Access Compliance Report

Public Rights-of-Way

(Curb Ramps)

| Intersection ID: 13704 | Main Street: CHESTERFIELD_AV | Cross Street: THE_PLAZA | Location: | N |

| ADA ID: 9BB109D9A393 | Ramp Type: PerpDiag | Initial Pass/Fail: Fail | Overall Compliance: No | Severity Score: 33.75 |

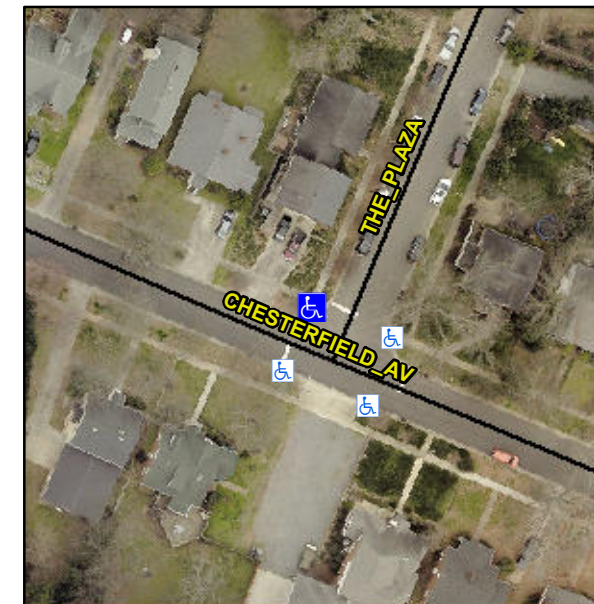
Remove & Replace Curb Ramp With Two New Directional Ramps or Equivalent.

R304.5.1, R304.2.2, R304.5.3

| Compliance | Description | Data | Compliance | Description | Data |
|------------|-----------------------|-------|------------|-----------------------------|-------|
| N/A | Ramp Length (in) | 75.5 | No | Ramp Slope (%) | 8.6 |
| No | Ramp Width (in) | 43.0 | No | Ramp XSlope (%) | 5.5 |
